# SERVICETEKNOTES

TABLE OF CONTENTS

Figure 1.

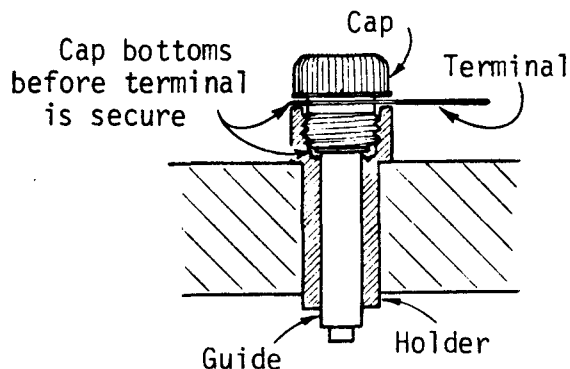
A problem has been seen on some of these new holders. The cap may bottom out within the holder before the hook-shaped terminal is secured (see figure 1). This poor connection may result in erratic motor speed and random cutter actuation. While tightening the cap to secure the terminal, the overzealous specialist (ARTICLE CONTINUED ON THE NEXT PAGE)

may break the cap, shear off the top of the holder or rotate the holder. If the holder is rotated, damage will occur on power up as the brush cuts into the armature.

The vendor is remedying the problem by using a shorter cap and recessing the brass guide. The field may wish to shim the brush cap using a 210-0012-00 lock washer (see figure 2). This will be necessary as some "defective" motors were shipped prior to discovery of the problem. Lot codes that are particularly suspect are HW, JW, KW and LW.

Figure 1

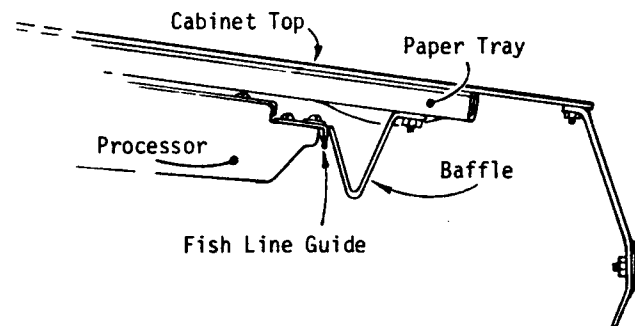
When replacing processors in the 4631 and 4632 hard copy units, it is important to compare the lengths of the

fishline paper guides between the old and new processors. If an earlier, shorter chrome guide (P/N 351-0378-00) is being replaced by a newer, longer black guide (P/N 351-0582-00), two problems are possible.

First, if the baffle in the top cover rubs against the fishline guide, eventual breakage of the fishline will result. Second, when the cover is closed to set the switch panel height for no light leaks, the baffle may catch under the new, longer paper guide. The cover may now be locked in place and not removed without damage to either the baffle, the paper guide, or both.

The solution is to use caution when closing the cover on a new processor for the first time. With the switch panel lowered to present the worst case, slowly lower the cabinet top. At the first hint of binding between the paper guide and the baffle, the cover should be raised and the baffle bent slightly to prevent interference. Continue in this manner until it is certain that the baffle and paper guide won't interfere. Then, set the switch panel for the correct height.
